HL-5286

Edwin I. Hatch Nuclear Plant  
Third 10-Year Interval Inservice Inspection Program  
Request for Relief

**GEORGIA POWER COMPANY  
HATCH NUCLEAR PLANT, UNITS 1 & 2  
THIRD 10-YEAR INTERVAL  
REQUEST FOR RELIEF NO. RR-18**

E.I. HATCH UNIT 1- RPV NOZZLE LOCATIONS  
AND INTERFERENCES

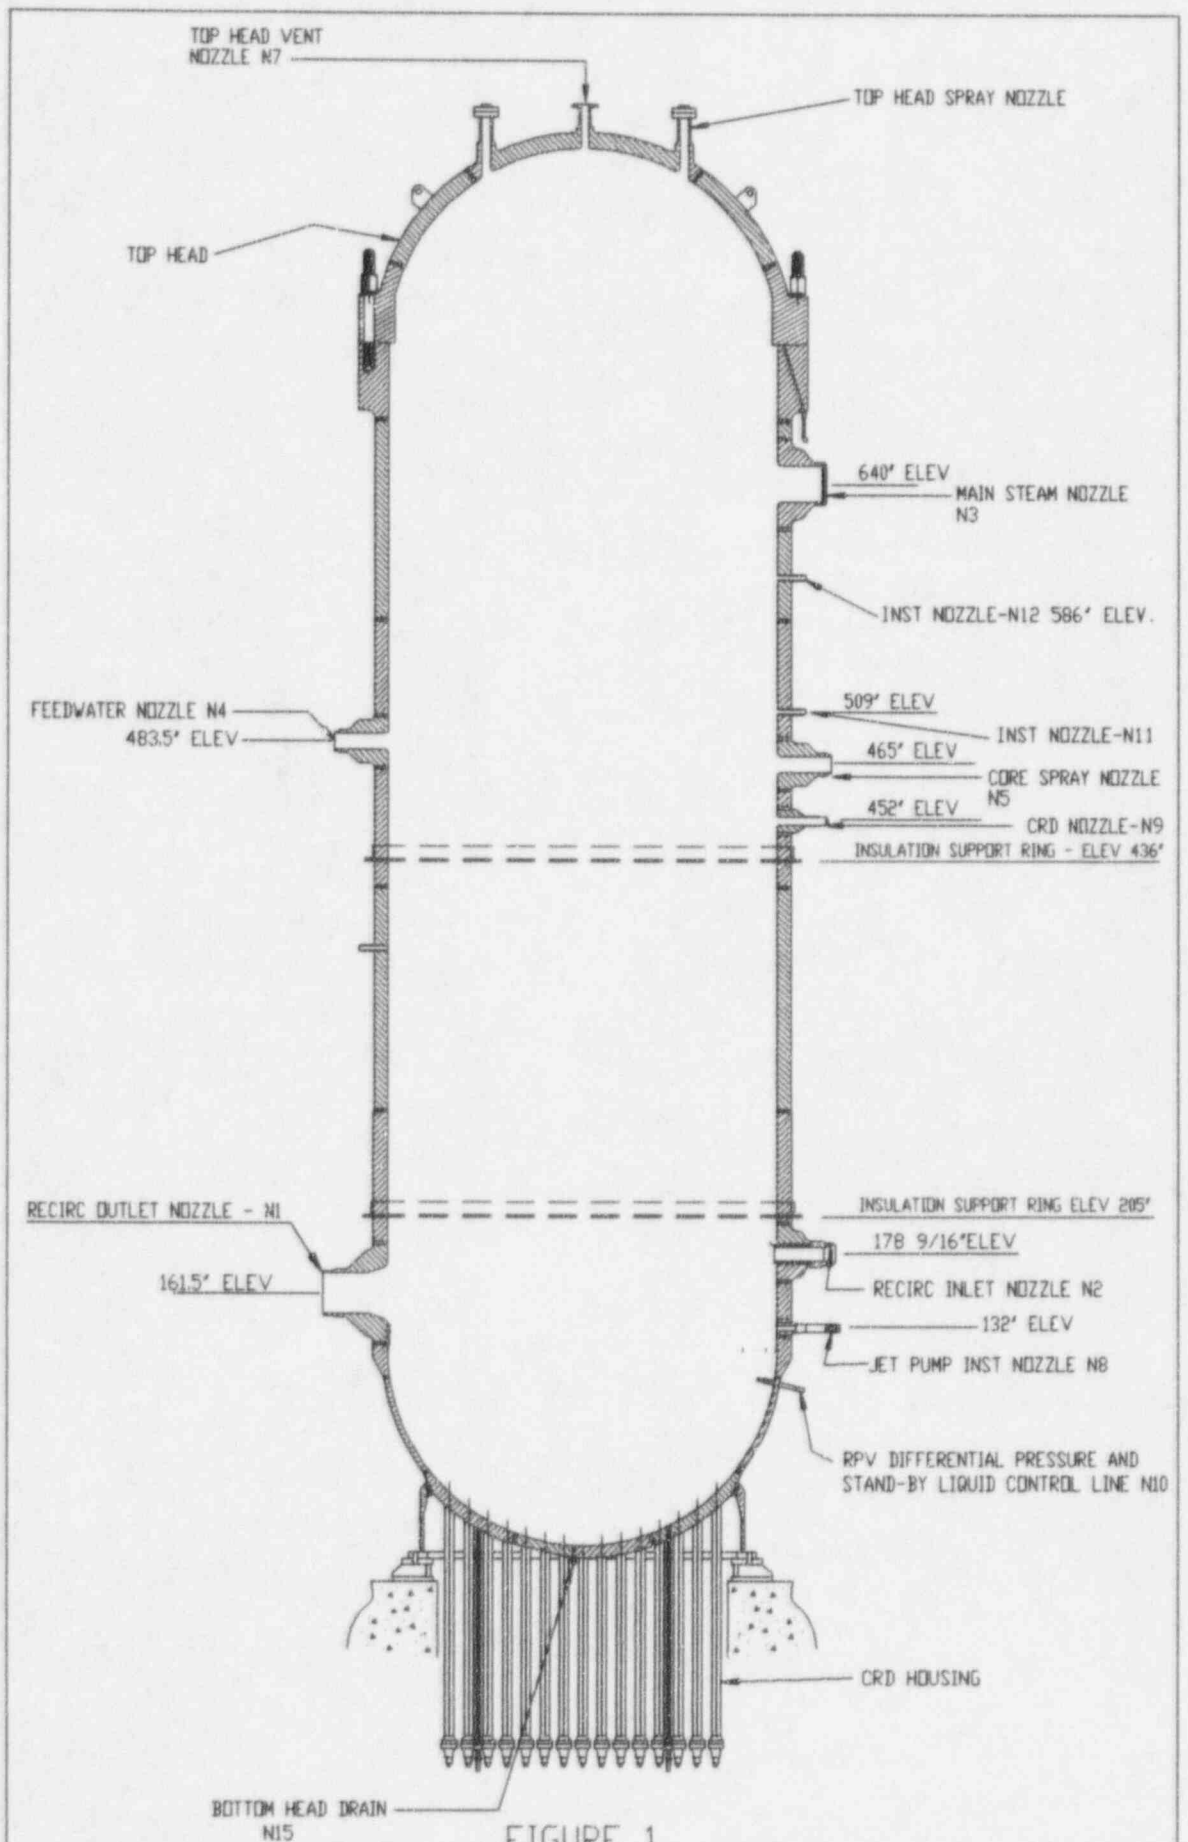
**N1A, B - Recirculation Outlet Nozzle-To-Vessel Welds** - For this nozzle configuration, the weld is located in the curved, blend radius of the nozzle; therefore, ultrasonic scanning can only be performed on the RPV vessel up to the point where the curvature begins. For this configuration, approximately 60% of the required examination volume is scanned from the one side. (See Figures 1 and 3).

**N2A-H, J-K - Recirculation Inlet Nozzle-To-Vessel Welds** - For this nozzle configuration, the weld is located in the curved, blend radius of the nozzle; therefore, ultrasonic scanning can only be performed on the RPV vessel up to the point where the curvature begins. For this configuration approximately 50% of the required examination volume for 95% of the weld length is scanned from the one side. The 5% limitation exists due to a welded insulation ring that is located just above the nozzles. (See Figures 1, 2, and 4).

**N3A, B, C - Main Steam Nozzle-To-Vessel Welds** - For this nozzle configuration, the weld is located in the curved, blend radius of the nozzle; therefore, ultrasonic scanning can only be performed on the RPV vessel up to the point where the curvature begins. For this configuration, approximately 40 to 50 % of the required examination volume is scanned from the one side. (See Figures 1 and 5).

**N3D - Main Steam Nozzle-To-Vessel Welds** - For this one nozzle, the geometry is similar to that of the main steam nozzles for Unit 2, in that, the weld is located such that ultrasonic scanning can be performed on the RPV vessel, on the weld, and on a small portion of the nozzle. For this configuration, approximately 75% of the required examination volume is scanned from the one side. Note: Even though there are differences (e.g., extent of cladding), Figure 10 which depicts the Unit 2 nozzles can also be used to adequately depict the geometry for this nozzle. (Also see Figure 1).

**N4A-D - Feedwater Nozzle-To-Vessel Welds** - For this nozzle configuration, the weld is located in the curved, blend radius of the nozzle; therefore, ultrasonic scanning can only be performed on the RPV vessel up to the point where the curvature begins. For this configuration, approximately 40 to 50% of the required examination volume is scanned from the one side. (See Figures 1 and 6).

**N5A, B - Core Spray Nozzle-To-Vessel Welds** - For this nozzle configuration, the weld is located in the curved, blend radius of the nozzle; therefore, ultrasonic scanning can only be performed on the RPV vessel up to the point where the curvature begins. For this configuration, approximately 40 to 50% of the required examination volume is scanned from the one side. (See Figures 1 and 7).

**N6A, B and N7 - RPV Head Nozzles** - These small nozzles located on the RPV head have a configuration such that coverage from one side is only approximately 40 to 50% for the N6A, B nozzles and 50% for the N7 nozzle. An evaluation of the configuration shows that these small nozzles have a very short radius. With this configuration, scanning can only be performed on the head and possibly a portion of the weld. (See Figures 1, 13 and 14).

**N8A-B - Jet Pump Instrument Nozzles** - These small nozzles have a configuration such that coverage from one side is in the range of 50 to 60%. An evaluation of the configuration shows that these small nozzles have a very sharp radius. With this configuration, scanning can only be performed on the shell and possibly a portion of the weld. (See Figures 1 and 15).

**N9 - CRD Nozzle-To-Vessel** - For this nozzle configuration, the weld is located in the curved blend radius, such that, ultrasonic scanning can only be performed on the RPV up to the point where the curvature begins. For this configuration, approximately 50 to 60% of the required examination volume is scanned from the one side. (See Figures 1 and 16).

HATCH UNIT 2-RPV RECIRCULATION OUTLET NOZZLE 2N1A,B

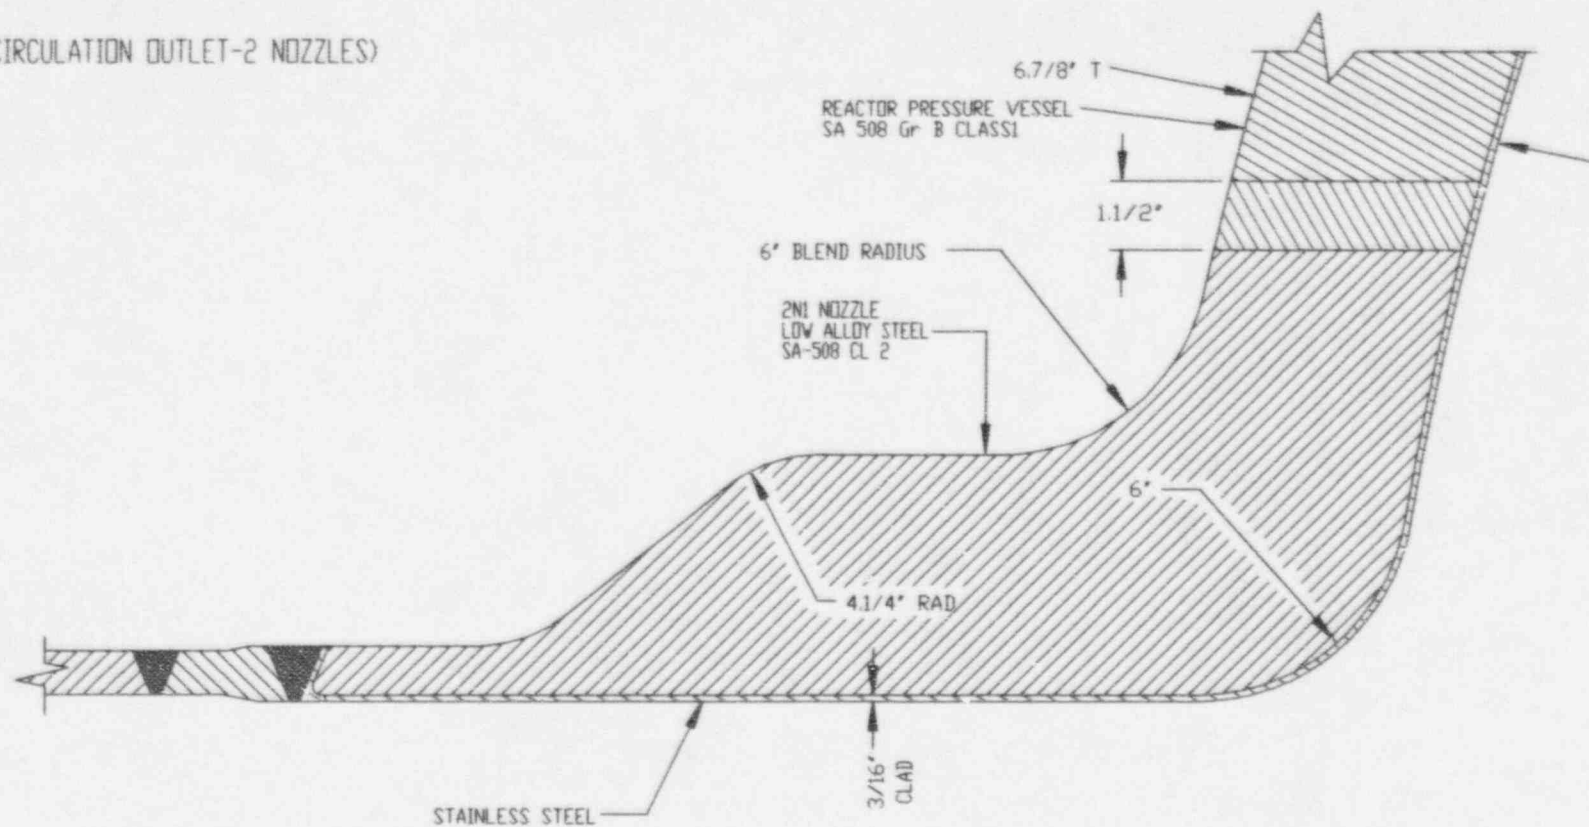
**2N1A, B - Recirculation Outlet Nozzle-To-Vessel Welds** - For this nozzle configuration, the weld is located such that ultrasonic scanning can be performed on the RPV vessel, on the weld, and on a small portion of the nozzle. For this configuration, approximately 80% of the required examination volume is scanned from the one side. (See Figure 8)

HATCH UNIT 2-RPV RECIRCULATION INLET 2N2A,B,C,D,E,F,G,H,J,K

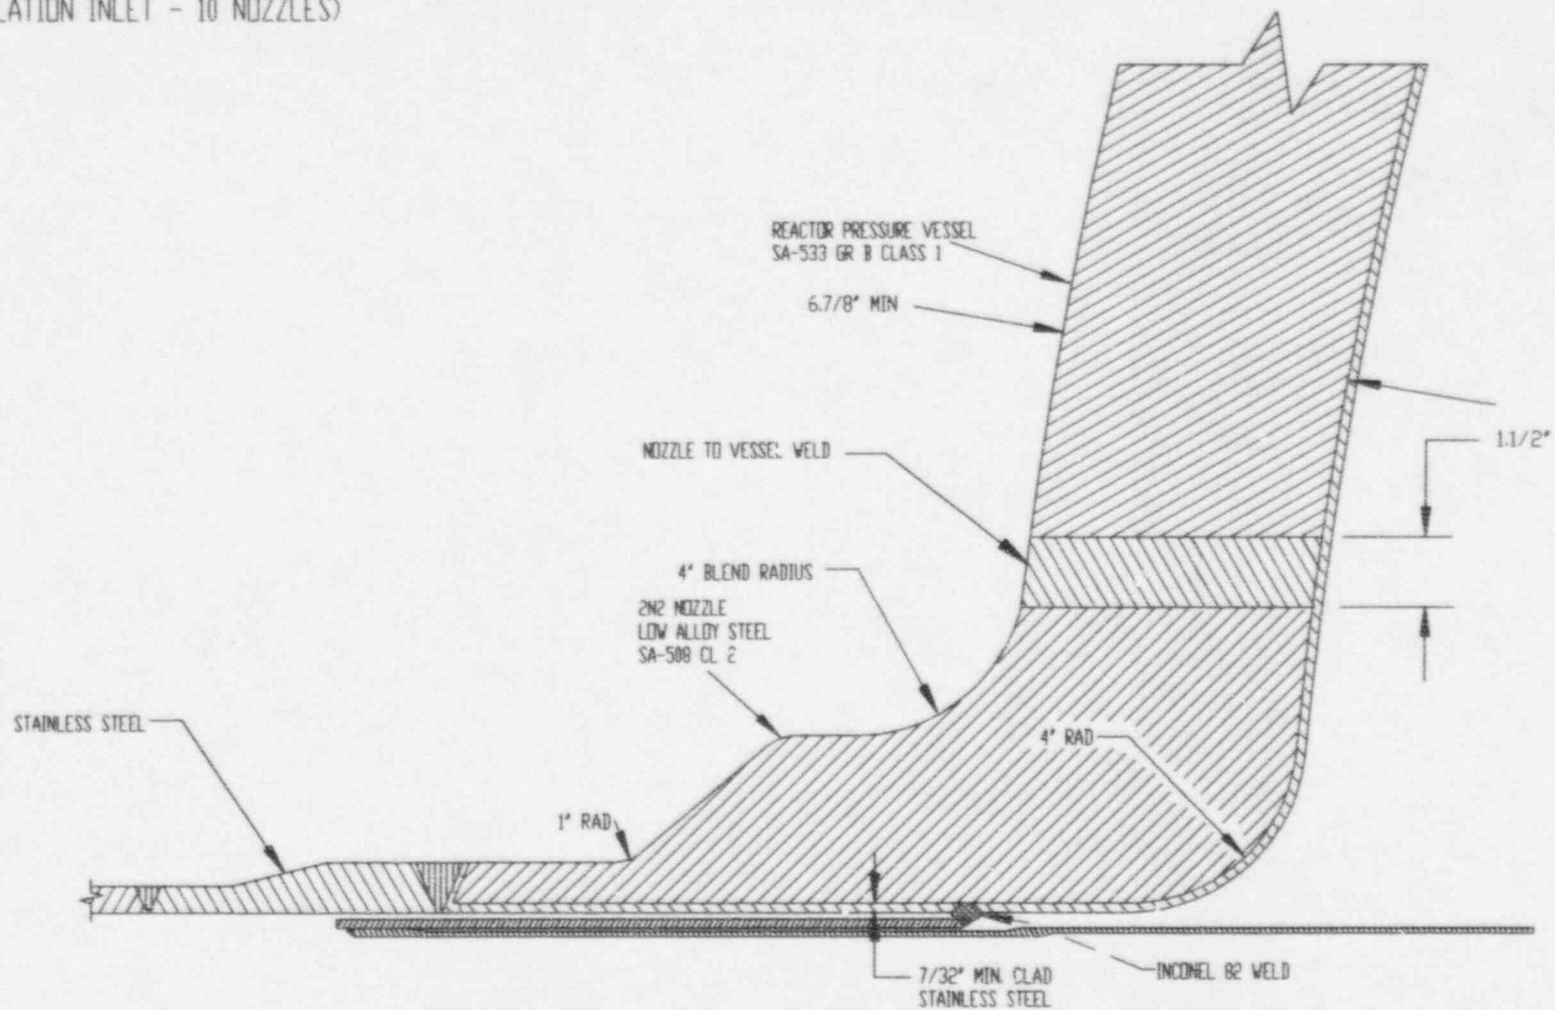
**2N2A-H, J-K - Recirculation Inlet Nozzle-To-Vessel Welds** -. For this nozzle configuration, the weld is located such that ultrasonic scanning can be performed on the RPV vessel, on the weld, and on a small portion of the nozzle. For this configuration, approximately 75% of the required examination volume is scanned from the one side. (See Figure 9 ). (Note: The welded insulation ring is not present on Unit 2).

HATCH UNIT 2-RPV MAIN STEAM NOZZLE 2N3A,B,C,D (AND HATCH UNIT 1 N3D)

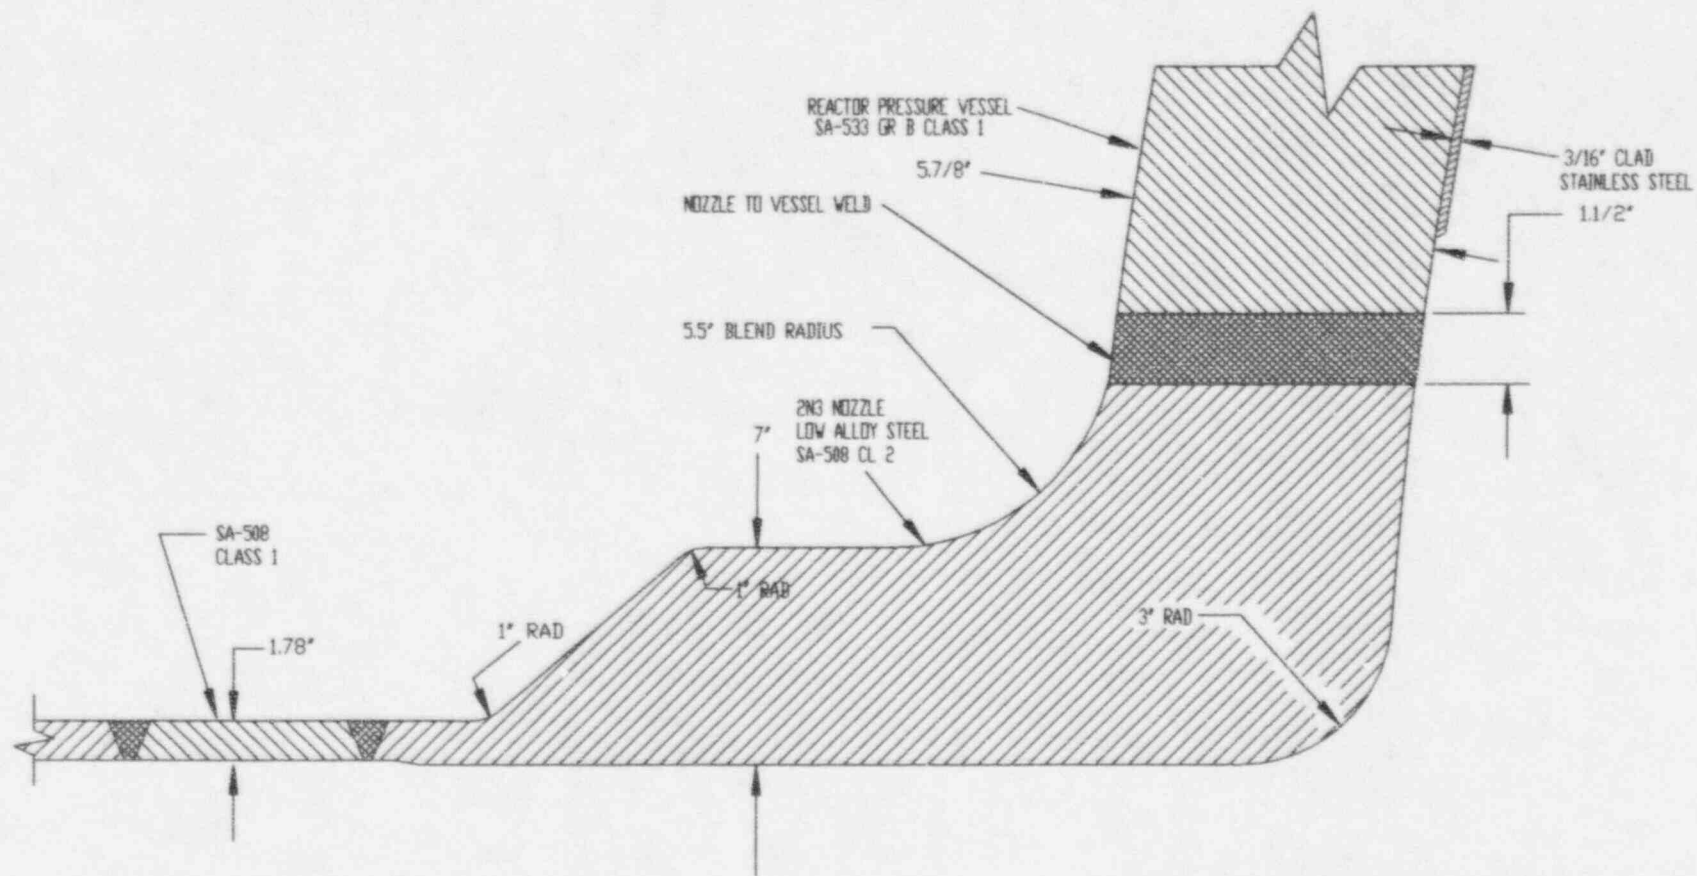
**2N3A-D - Main Steam Nozzle-To-Vessel Welds** - For this nozzle configuration, the weld is located such that ultrasonic scanning can be performed on the RPV vessel, on the weld, and on a small portion of the nozzle. For this configuration, approximately 75% of the required examination volume is scanned from the one side. (See Figure 10).

HATCH UNIT 2-RPV FEEDWATER NOZZLE 2N4A,B,C,D

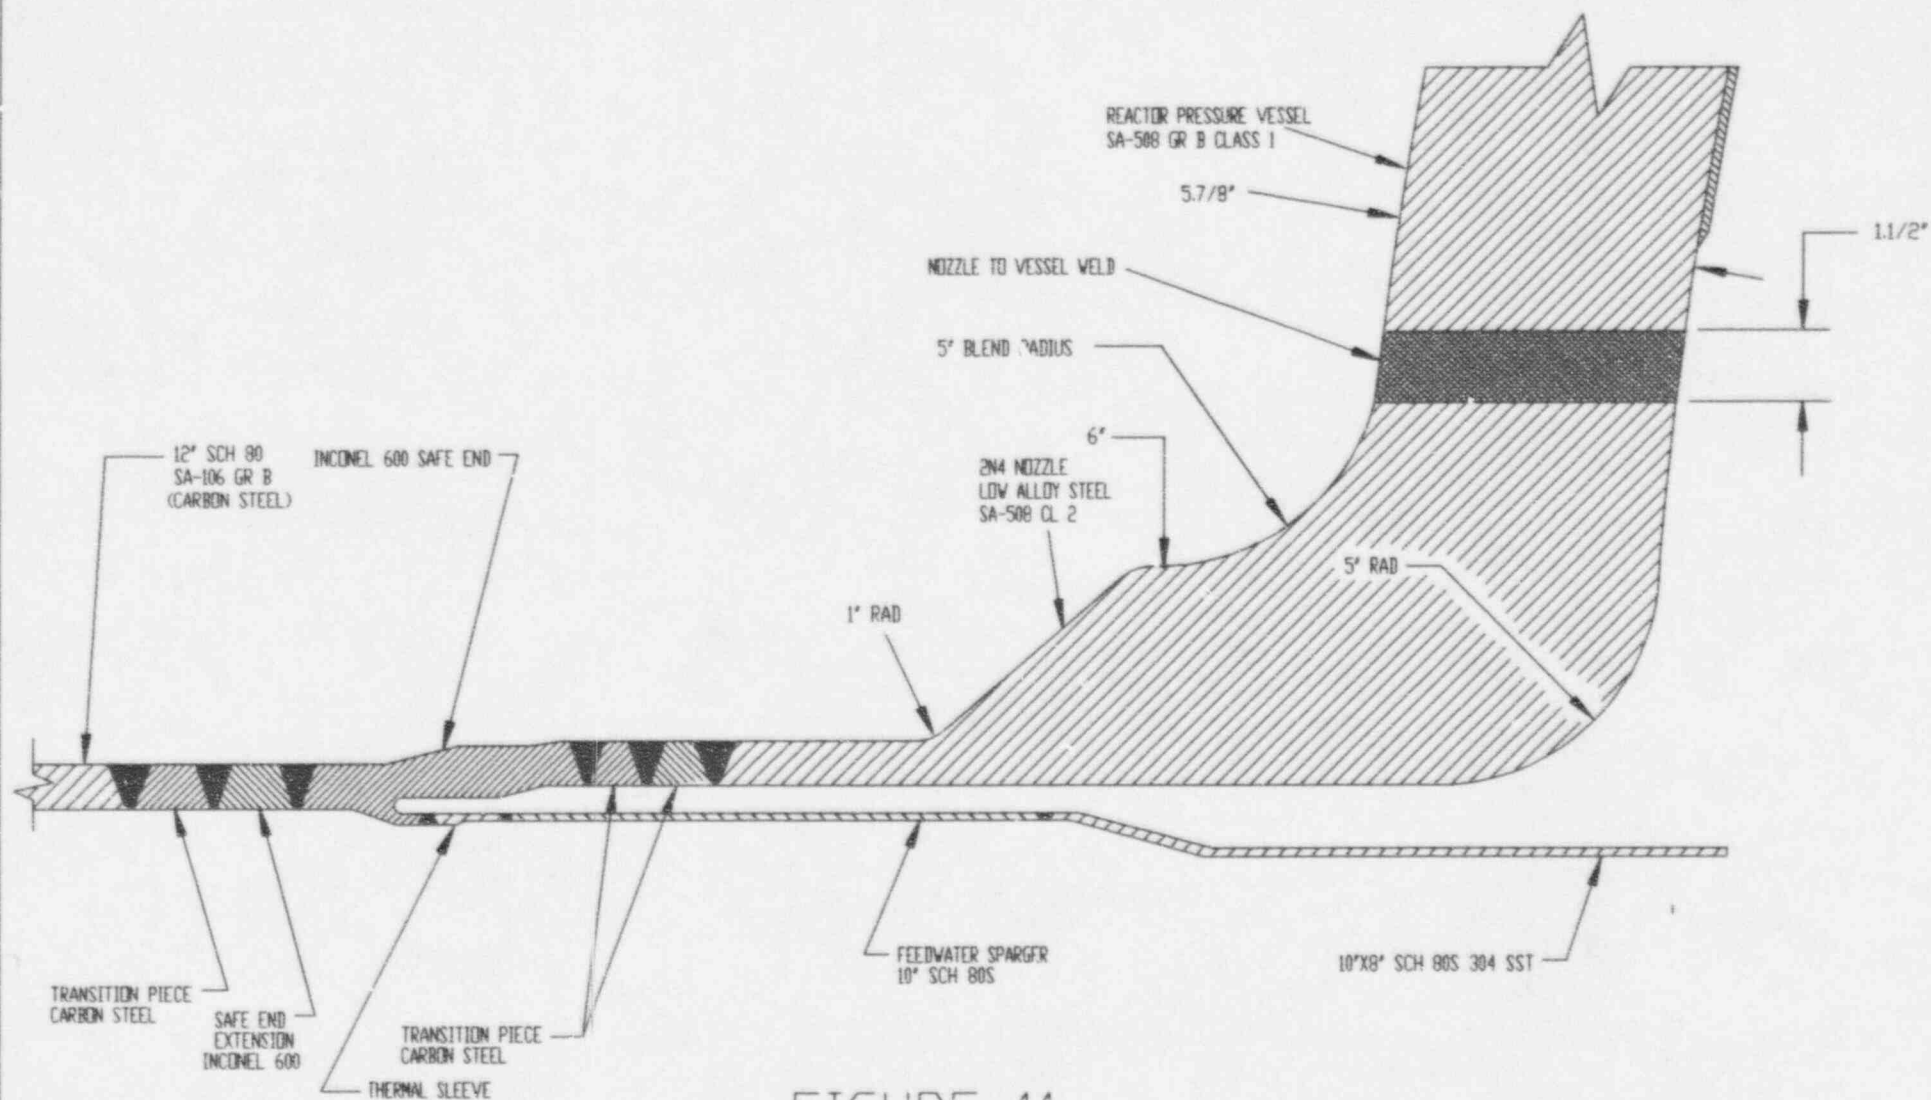
**2N4A-D - Feedwater Nozzle-To-Vessel Welds** - For this nozzle configuration, the weld is located such that ultrasonic scanning can be performed on the RPV vessel, on the weld, and on a small portion of the nozzle. For this configuration, approximately 80% of the required examination volume is scanned from the one side. (See Figure 11).
